WARRANTY BULLETIN

CAN-AM® ROADSTER

Subject: **Gearbox Position Sensor Contamination**

No. **2015-7**

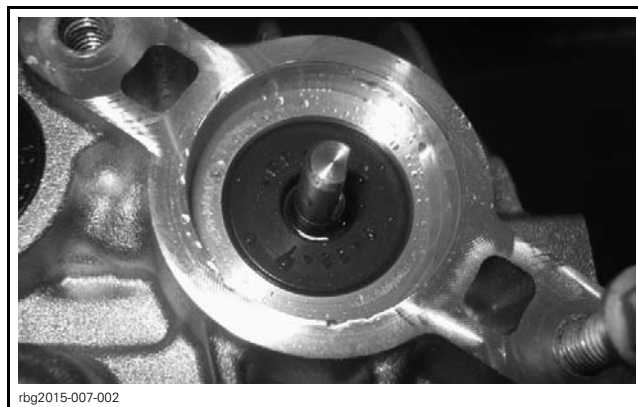
A limited quantity of vehicles were shipped with liquid contaminants in the gearbox position sensor (GBPS) housing that will damage the sensor.

A damaged GBPS may lead to; P-codes, limp home mode activation or vehicle does not shift.

Replace GBPS and clean its housing.

NOTICE Make sure to clean and dry all dust and liquid contaminants on the crankcase before the installation of the new GBPS.
